ADDENDUM NO. 1
7/18/2025

PROJECT: CITY OF ABILENE
I-20 UTILITY RELOCATES - WORK AUTHORIZATION NO.1

27" EFF. REUSE LINE CONFLICT 1003 P&P
STA. 5+00-END

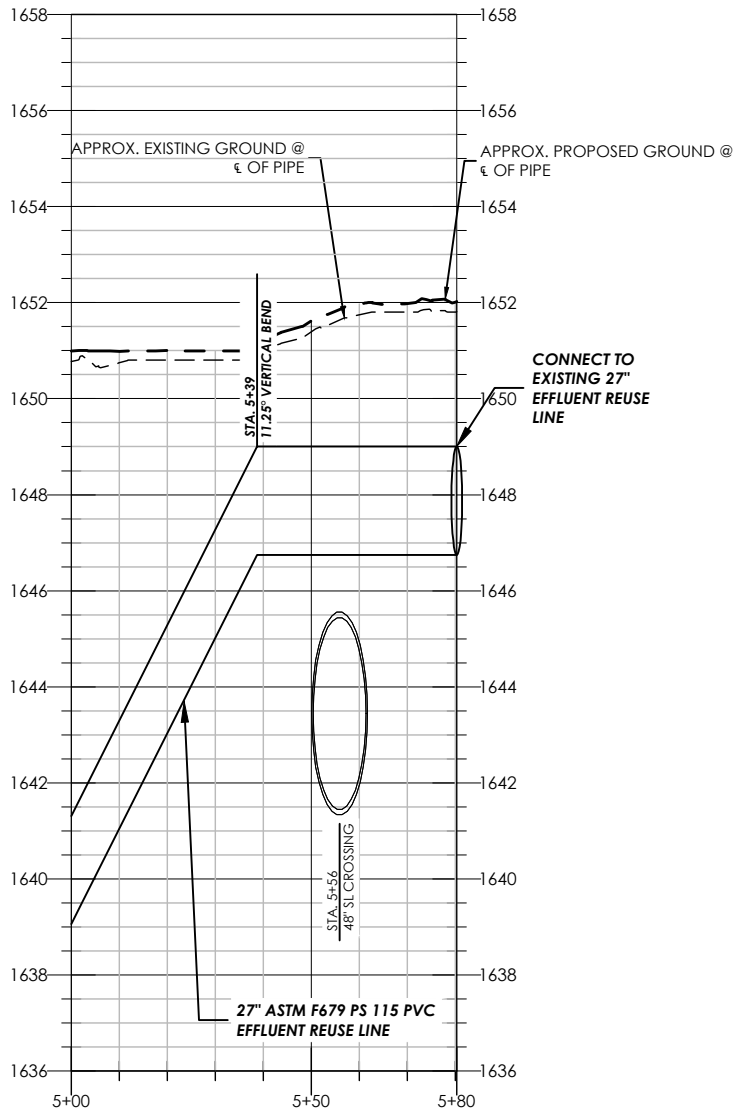
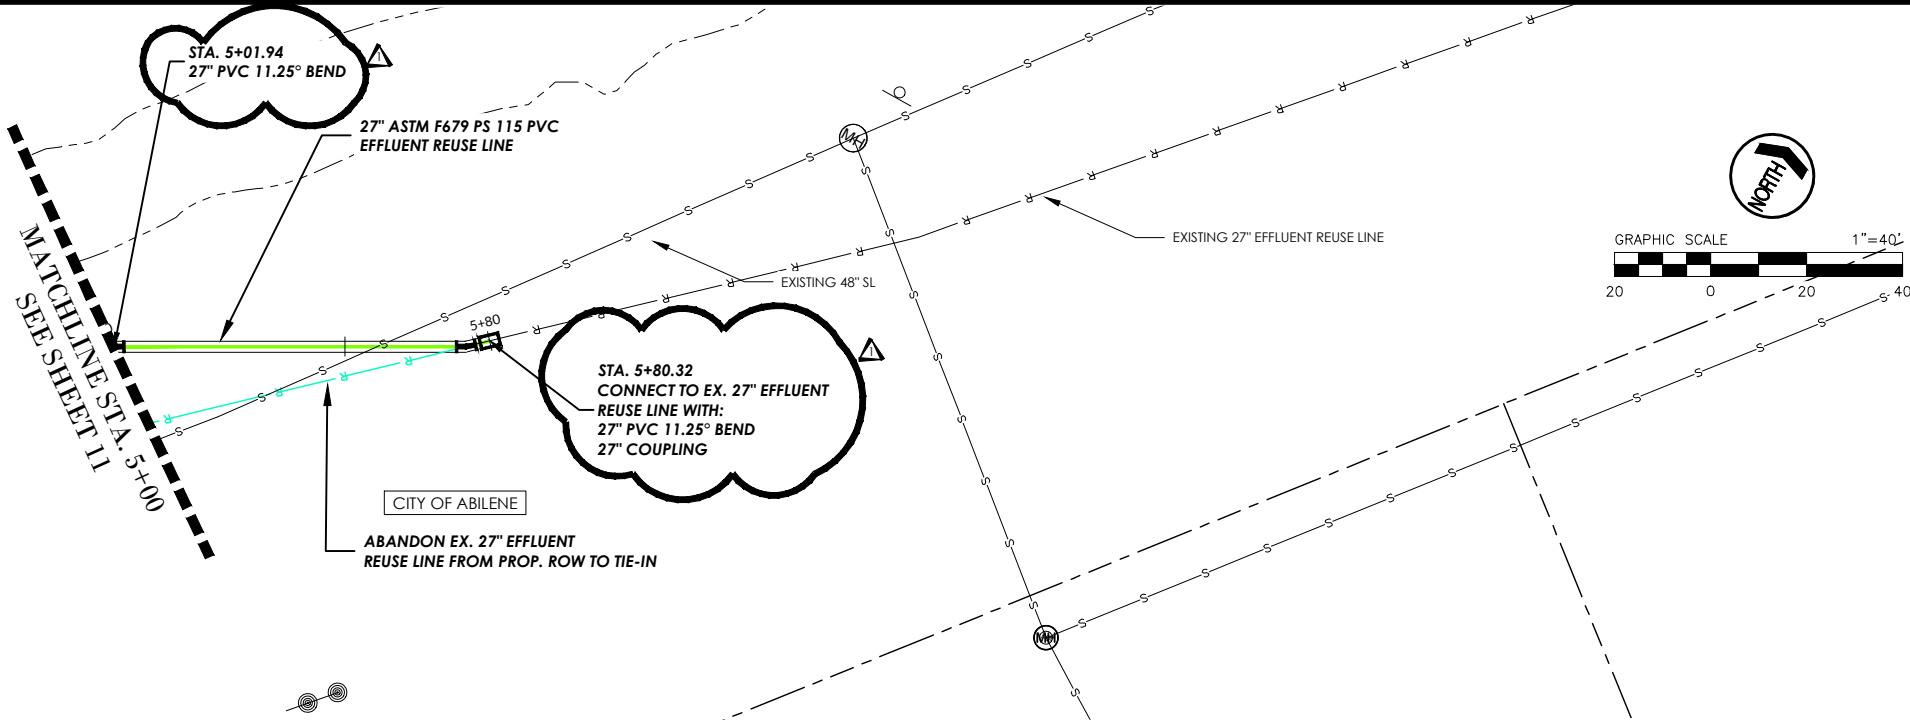
- a) Conflict 1003 (Sheets 11-12): Gasketed PVC fittings shall be used in lieu of DIMJ. PVC Fittings shall conform to ASTM F-679 and the gasket system must meet or exceed ASTM F-477. See attached revised plan sheets.

NO.	REVISION	DATE
1	CHANGE RITINGS FROM DNU TO PVC	07/18/2025
